Comment Date: May 2, 2011 14:17:41PM
Solar Energy Development PEIS
Comment ID: SolarD11812

Re: Endorsement of Cultural Resources Preservation Coalition Letter on Solar PEIS

Re: A NEPA EIS is no substitute for required FLPMA regulations

Figure 1. Existing ROW applications in proposed California SEZs.

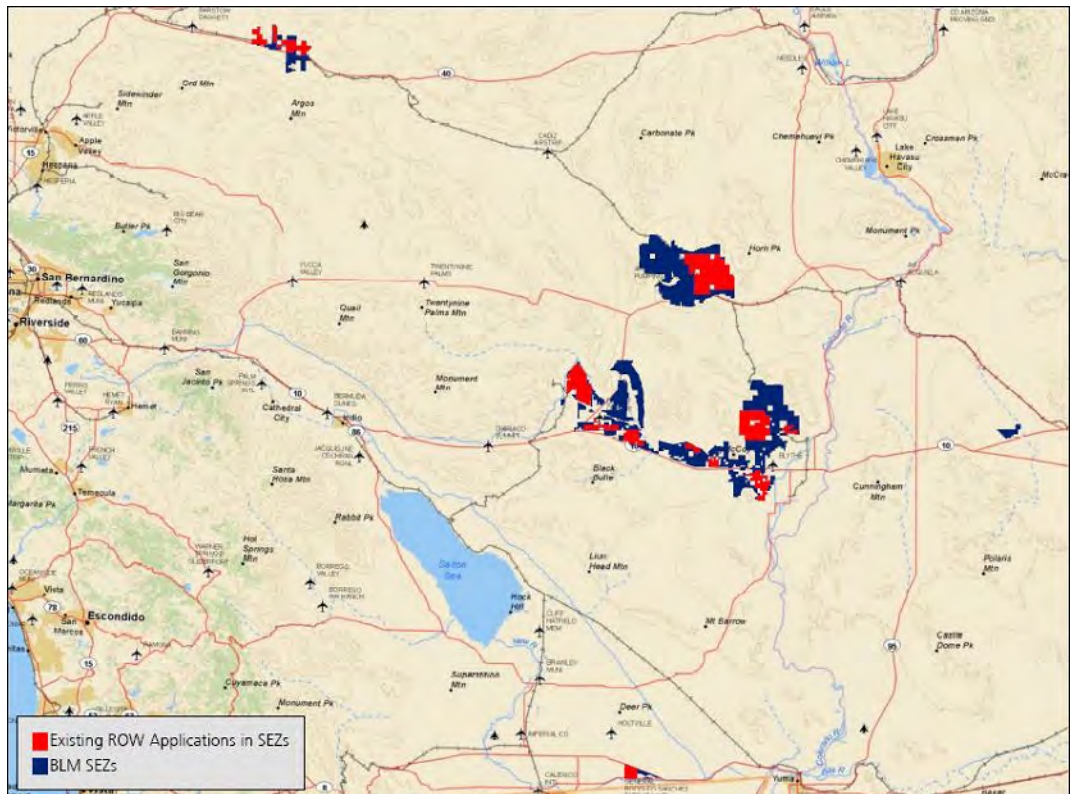
(i) Many of the proposed SEZs, particularly in California, already are the subject of pending applications.

According to data obtained from BLM public database for California,¹⁷ of the 339,090 acres currently proposed as SEZs, pending ROW applications already cover 108,864 acres. These applications reduce the supposed 677,384 acres available under the SEZs by 16% overall and by 32% in California. *See* Figure 1 and Table 1 below.

Figure 2. Suggested zone for studying the possibility of SEZs in the West Mojave.

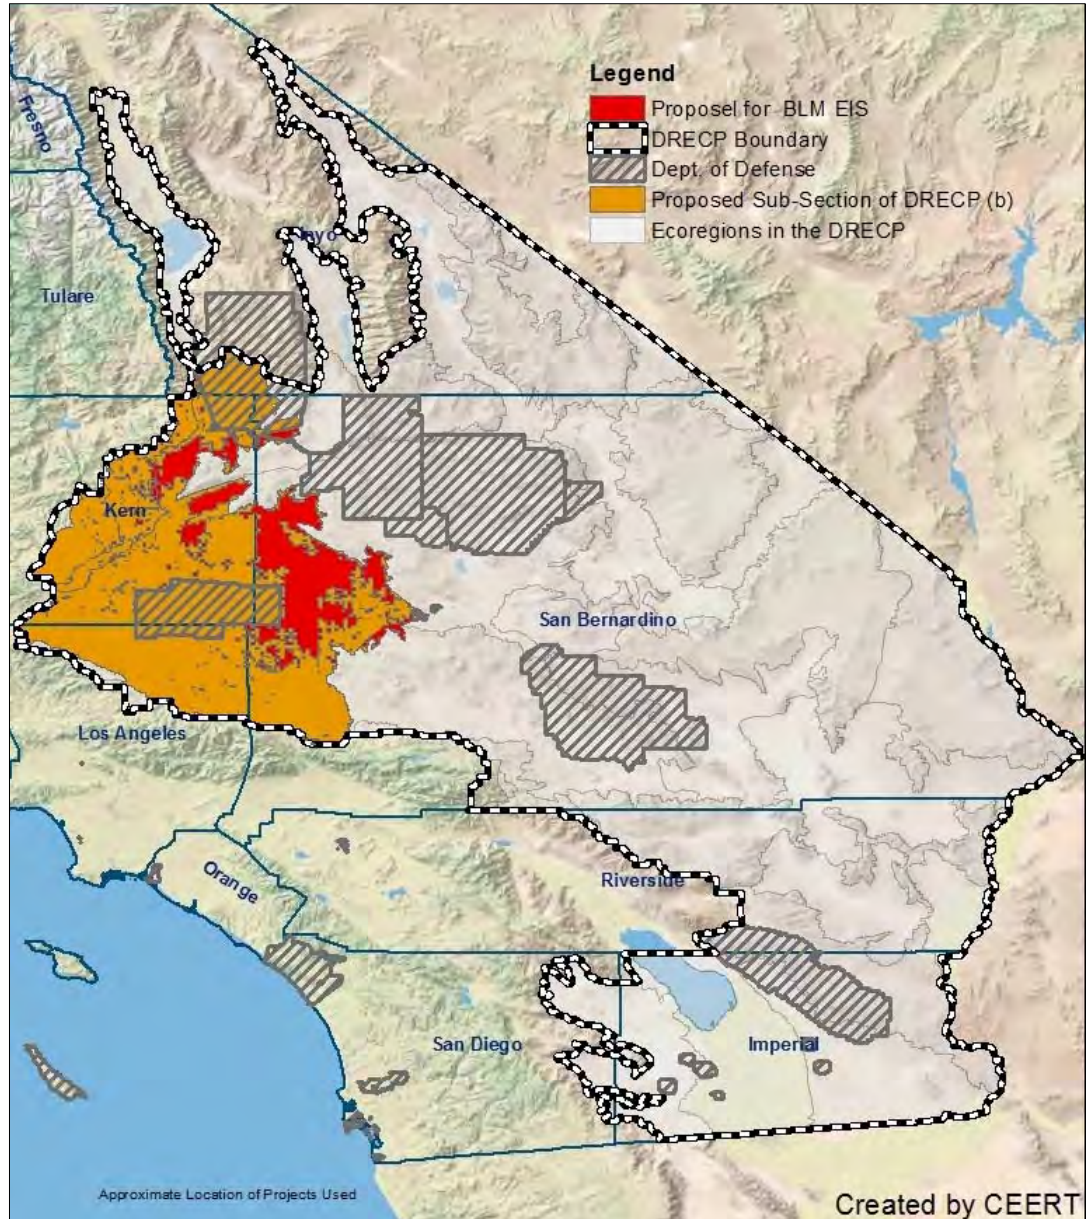
Admittedly, BLM’s planning and review of the West Mojave will require significant resources. Efforts being undertaken in other contexts may be leveraged to save some time. For example, the State of California, through the California Energy Commission, has recently launched an extensive vegetation mapping exercise, the results of which should provide important and timely information for the BLM’s review of the WEMO Plan, and for the California DRECP. In addition, CEERT, as part of its coordination of California’s Renewable Energy Transmission Initiative (RETI) planning effort, has developed a map of the West Mojave which identifies the recommended areas which should be evaluated by BLM as part of its analysis of the West Mojave as a new SEZ. Even with these resources, there is still much work to be done to identify SEZs, but it will

be worthwhile to provide for development opportunities in this region with unparalleled solar resources.

Figure 3. Proposed starting point for SEZ evaluations in the West Mojave.

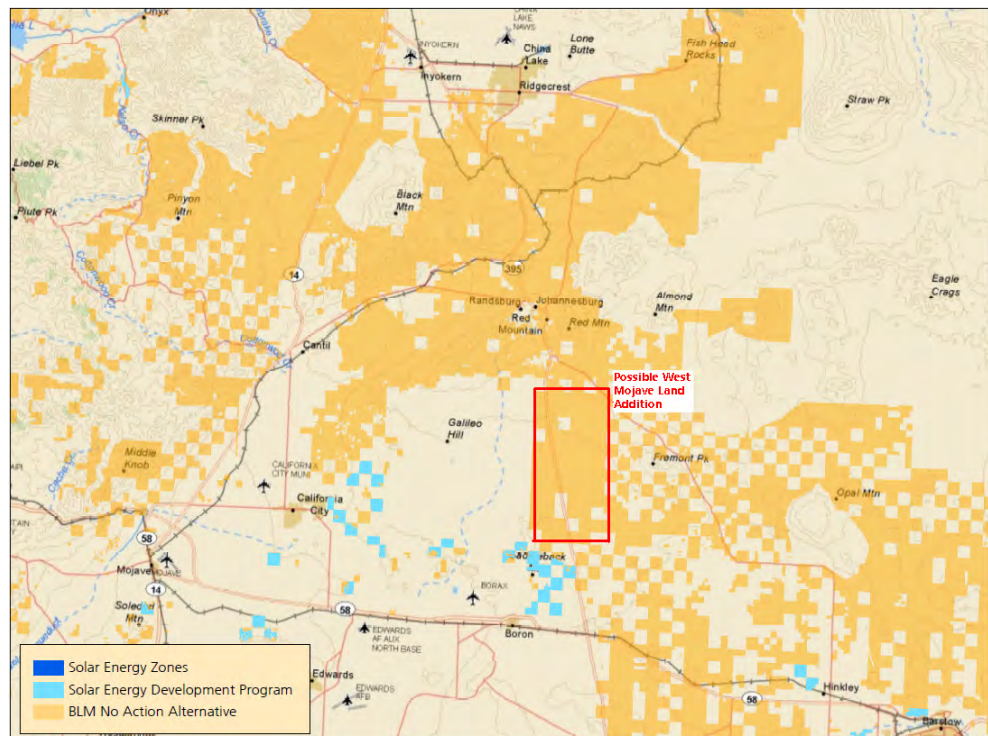
Consistent with the comments above, BLM should also consider designating more lands in Nevada and Arizona for solar development. In Arizona, we are informed that the BLM State Director excluded any acreage from SEZ consideration that is subject to a pending application. As a result, there were no applications in the areas that BLM identified as proposed SEZs, but many applications in other areas—thereby producing the opposite outcome intended for the PEIS; BLM should consider including those other areas. It is unclear how the proposed SEZs in Nevada were identified, or why there are not more SEZs in a state in which BLM manages 67% of the available land. These states have more and better areas with regard to insolation, load, and transmission, and the Draft PEIS unfairly ignores or minimizes the viability of their promising areas.

Solution: As stated above, BLM should establish a consistent process for identifying and approving new SEZs or SEZ expansions (assuming, of course, that those SEZs follow the recommendations we have laid out above). Such process will be important if BLM designates SEZs, and BLM should identify that process in the Final PEIS. BLM also should begin evaluating new potential SEZs in the West Mojave, Chocolate Mountains, lands identified in the Arizona Restoration Design Energy Project, and other areas. Figure 3 below depicts one possible area for West Mojave utility-scale solar development.

Figure 2. Land Conservation Values: No Action Alternative

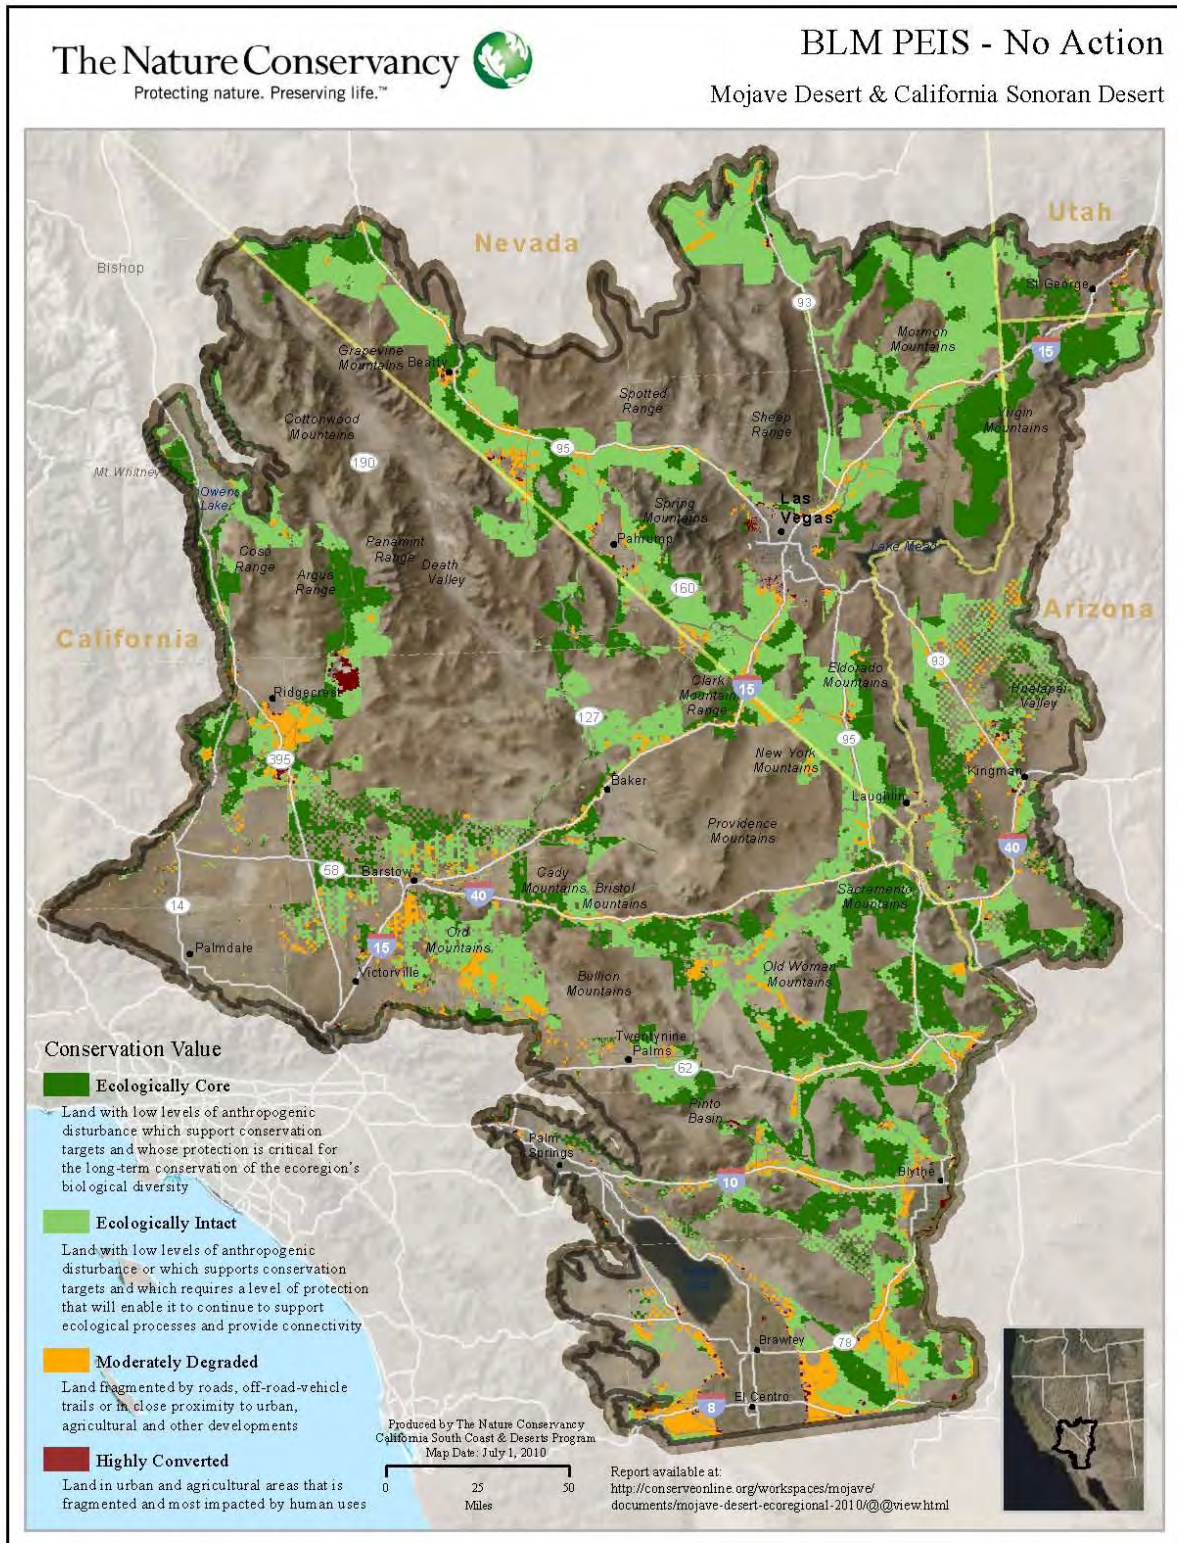
A closer look at the second generation assessments conducted for the California portions of the Mojave and Sonoran Deserts reveals that the No Action alternative encompasses 2,551,115 acres of Ecologically Core lands (Table 2; Figure 2). The Solar Energy Development Program alternative encompasses 685,103 acres of Ecologically Core land in California (Table 2; Figure 3), while the Solar Energy Zone alternative encompasses 182,356 acres (Table 2; Figure 4).

Pisgah

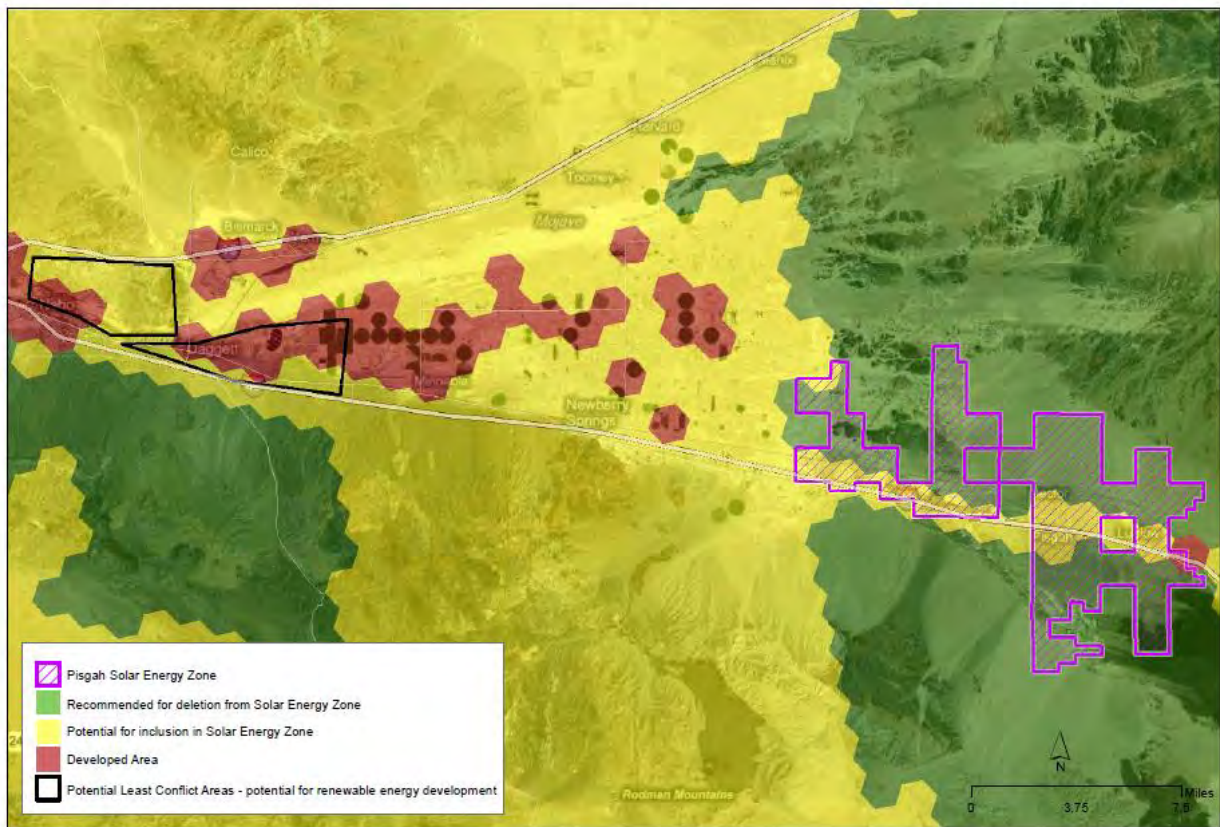
Nearly 80% of the Pisgah SEZ is comprised of ecologically core land; just over 20% of this land has a lower conservation value. Pisgah is immediately west of the triangle formed by the junction of southbound Interstate 15 and westbound Interstate 40 and near private, disturbed lands that already house an out-of-service solar array. The Conservancy recommends the Pisgah SEZ be withdrawn from consideration for ROW applications. Instead, the private lands immediately to the west may serve to replace this SEZ.

Figure 6. Amargosa Valley SEZ

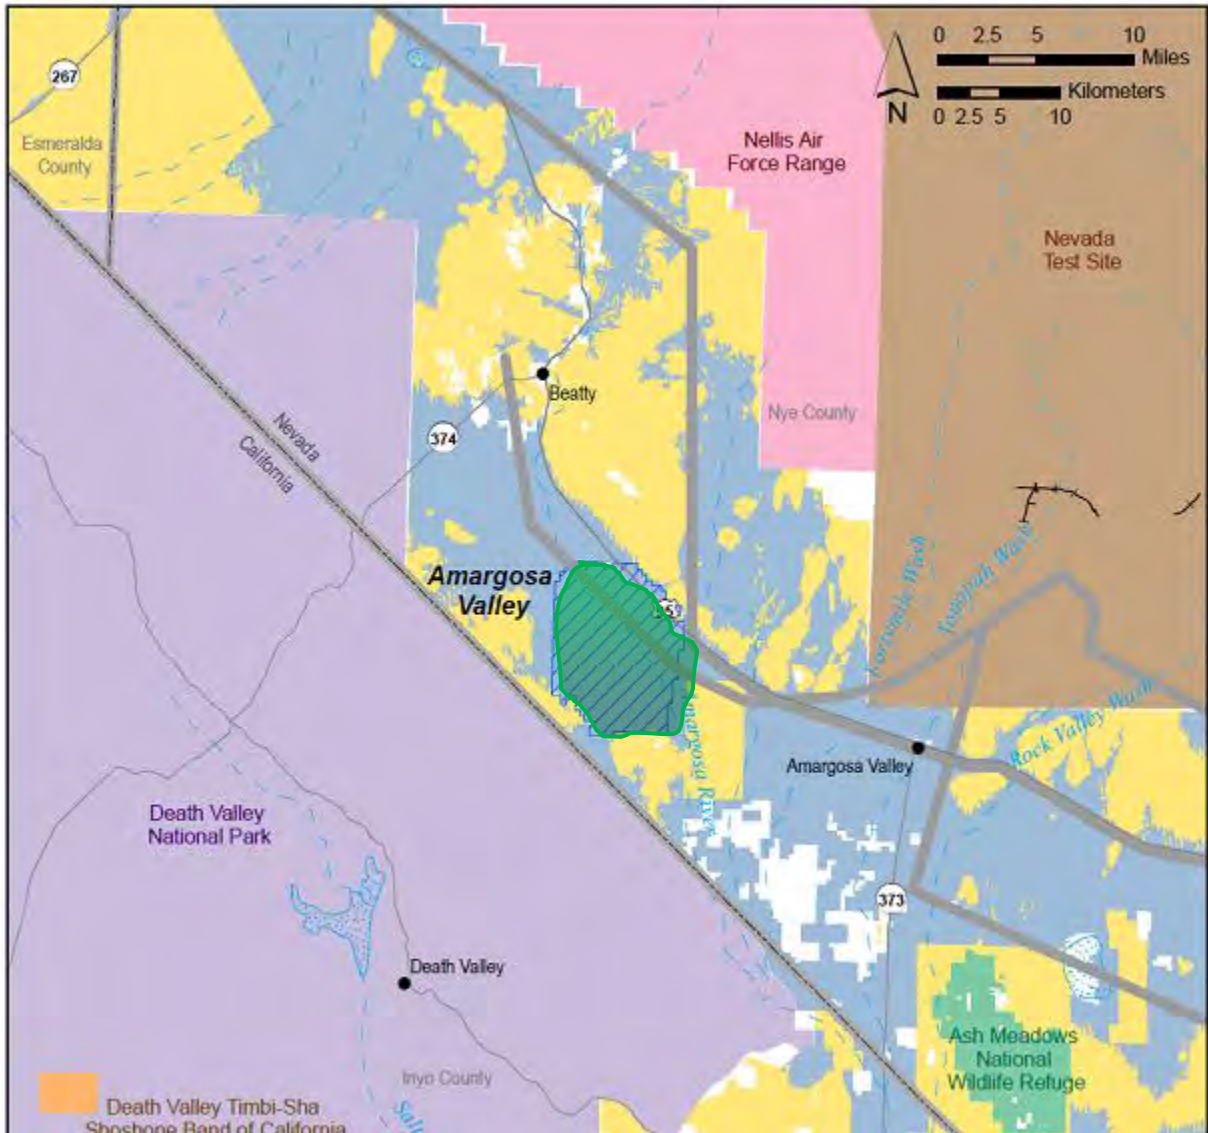
This valley (Figure 6) is already scheduled to be heavily compromised by ongoing existing renewable energy applications, two of which are on the fast track course. There has been no explanation why additional facilities are needed in this general area given the scale of the existing proposed facilities. According to the 2010 TNC Ecoregional Assessment for the Mojave Desert, the overwhelming majority of this SEZ is contained within Ecologically Core zone with an additional 4,500 acres of Ecologically Intact lands. Only roughly 11% of this SEZ is within Moderately Degraded category, and that principally located along US Highway 95.

If there is a credible argument to be made for additional renewable energy to be generated in this vicinity after the build-out of several existing fast track and prior applications for solar facilities, then any additional development should occur only in the moderately degraded corridor paralleling US 95. Otherwise, this SEZ should be eliminated from further consideration.

Figure 7. Big Dune in Amargosa Valley with Likely Sand Transport Pathways

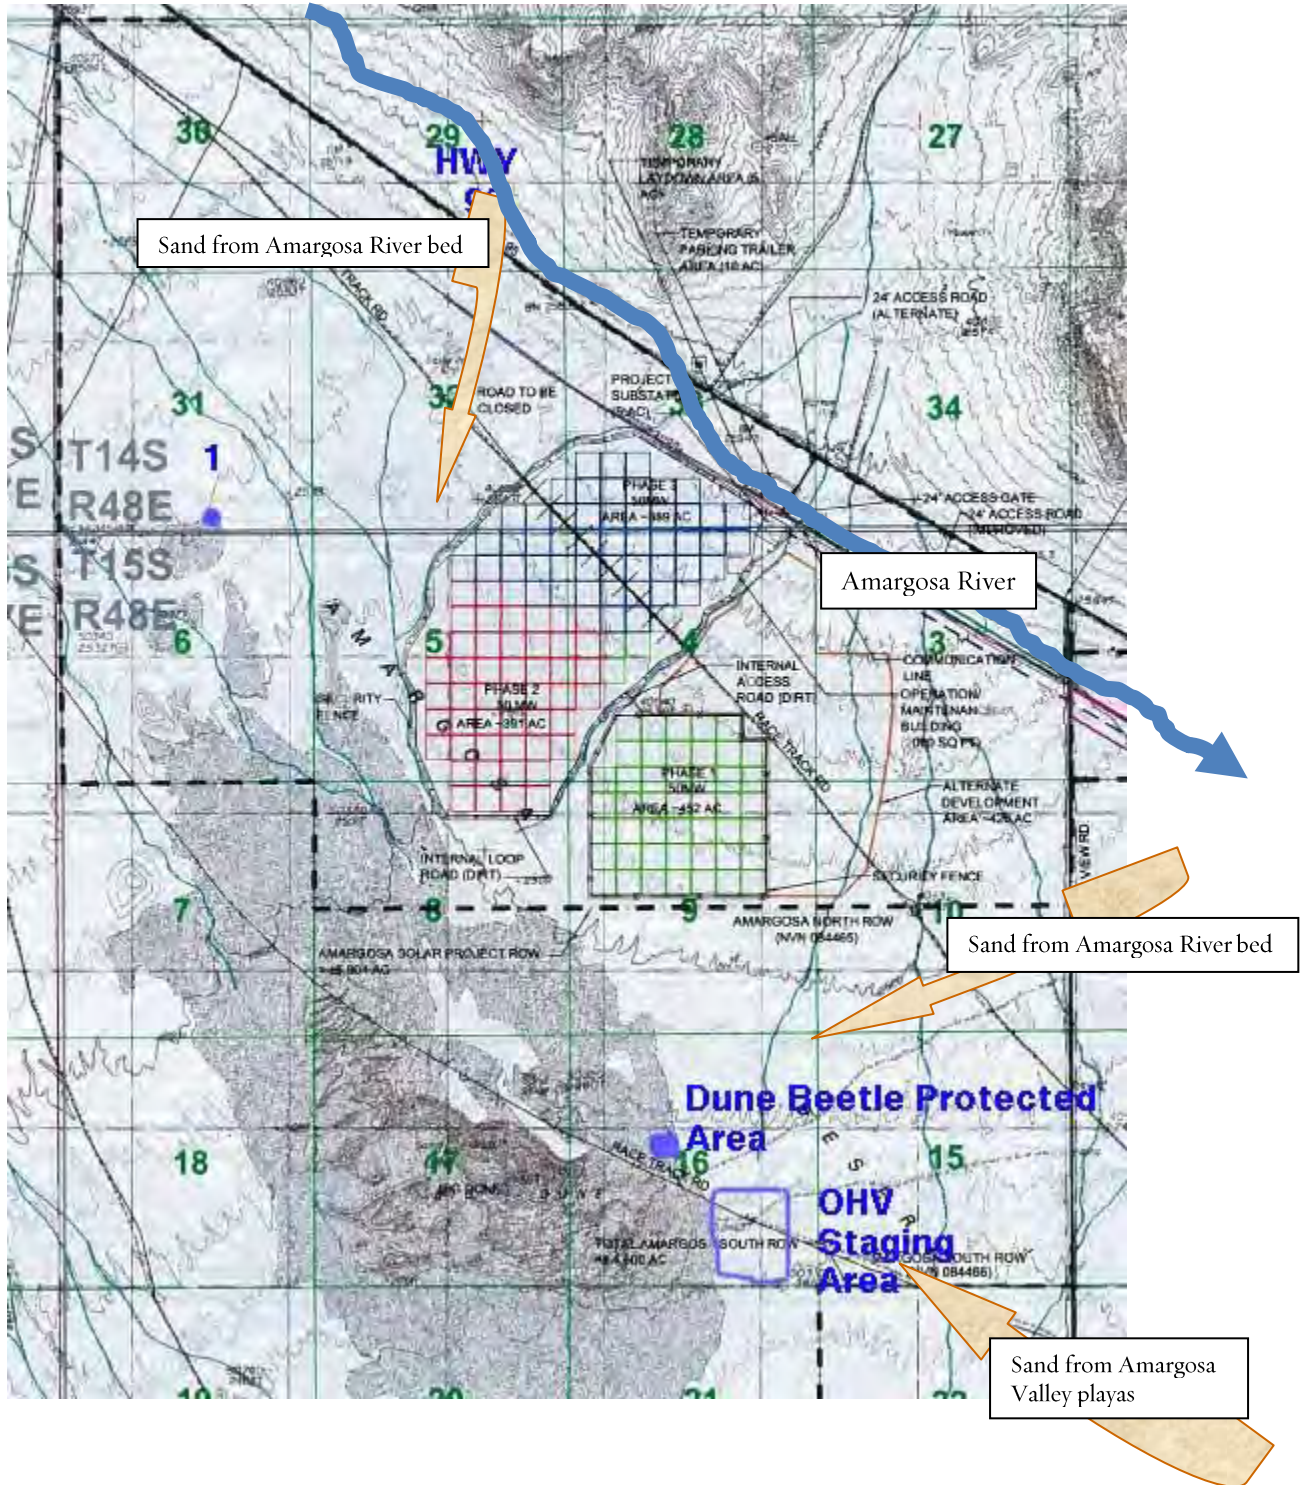
This valley is located within an important corridor of movement for desert tortoises in light of projected climate change. Currently occurring at low densities, this very lightly impacted valley of Mojave creosote-bursage scrub may be an important population center for this enigmatic desert species if climate trends continue. The Amargosa Valley groundwater basin is already overallocated and linked to critically important desert oases such as Oasis Valley to the north and Ash Meadows to the southeast. Additionally, the presence of Big Dune at the core of this valley should cause concern that the proliferation of renewable energy facilities will interrupt important sand transport pathways from the Amargosa River bed and nearby dry lake beds to the south and east of this valley (Figure 7).
